# Sakura Dyeing & Garments Ltd. (9876)

01.JUNE.2014

## Identified Priority 1 Concerns

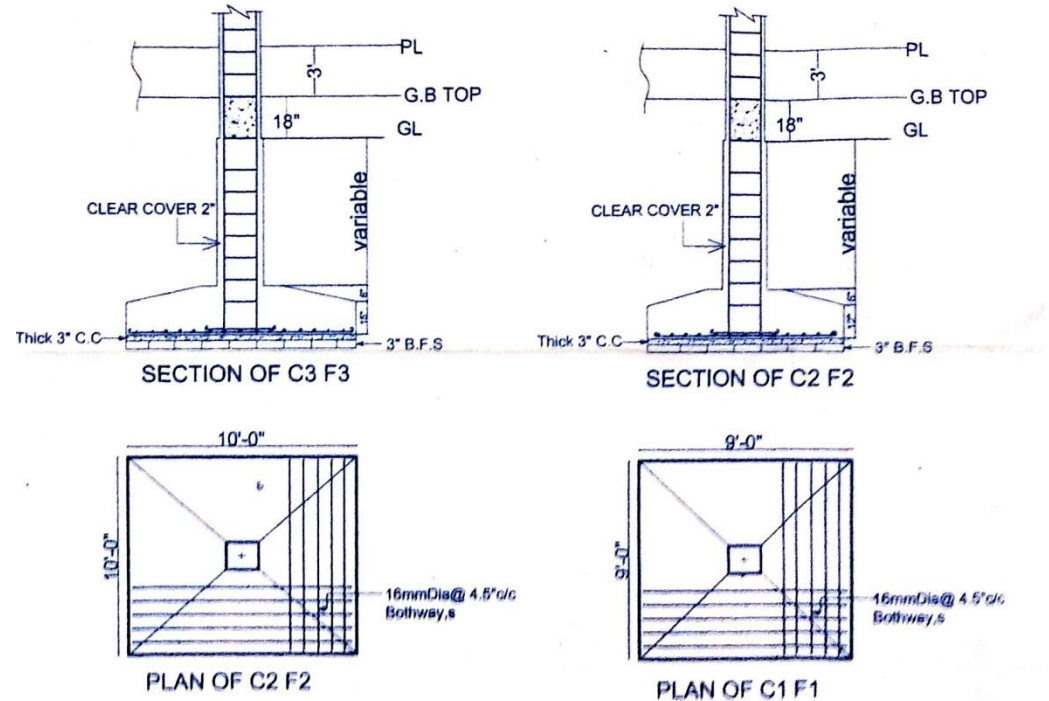
Left, extract from the Soil Test Report, stating that 'deep foundations' will be required. Right, structural drawings indicating pad foundations.

It must be established which type of foundations were used, and calculations provided to prove their capacity.

| Item No. | Observation                                                                                                                                                 | Recommended Action Plan                                                                                                                                                                                                                                          | Recommended Timeline |
|----------|-------------------------------------------------------------------------------------------------------------------------------------------------------------|------------------------------------------------------------------------------------------------------------------------------------------------------------------------------------------------------------------------------------------------------------------|----------------------|
| 4        | Priority 2 - Foundations indicated on structural drawings do not match the recommendations given in Soil Test Report.                                       | No additional load to be added to the structure before capacity is confirmed.<br>If over-capacity, Factory Engineer to design remedial measures or load reduction to ensure building stability.                                                                  | 6-months             |

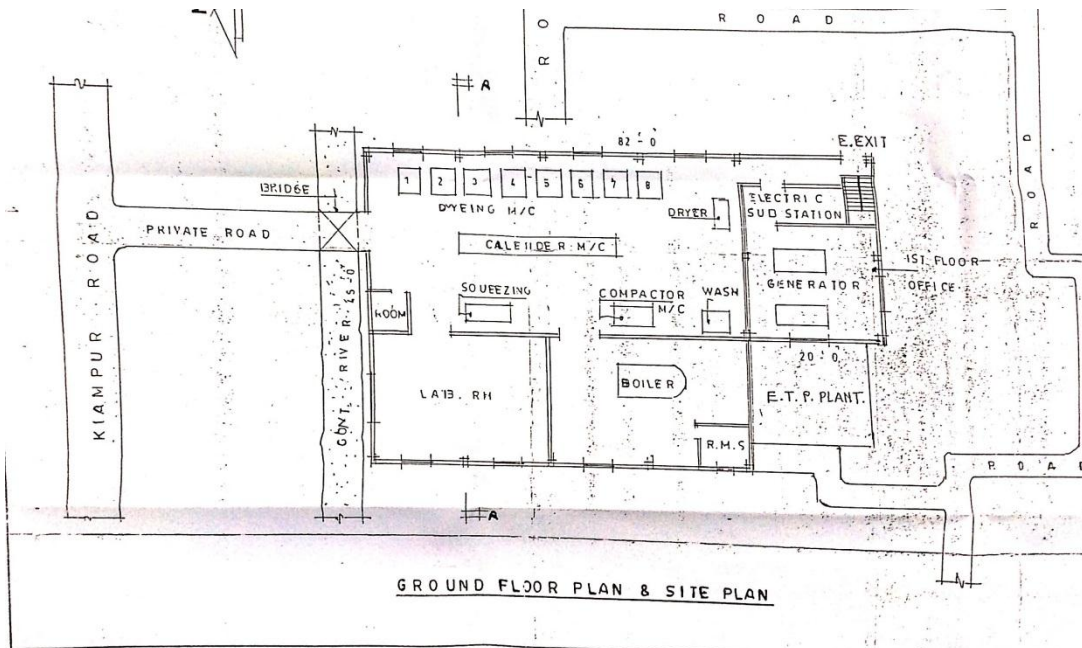
The column schedule to the right indicates a uniform column dimension for the full height of the building. In reality the columns were smaller at upper floor levels.

The drawing to the left is an indication of the level of information received for the three-storey building and associated steel/concrete sheds.

This level of information must be improved, with full structural drawings provided for all buildings on the site.

| Item No. | Observation                                                                                                                                                 | Recommended Action Plan                                                                                                                                                                                                                                          | Recommended Timeline |
|----------|-------------------------------------------------------------------------------------------------------------------------------------------------------------|------------------------------------------------------------------------------------------------------------------------------------------------------------------------------------------------------------------------------------------------------------------|----------------------|
| 5        | Priority 3 - Some discrepancies between structural drawings and observed site conditions, with some drawings entirely absent.                               | Factory Engineer to survey actual site conditions and revise drawings to match.<br>Where drawings were not provided, original design drawings to be recovered or, if lost, as-built drawings to be produced.                                                     | 6-months             |
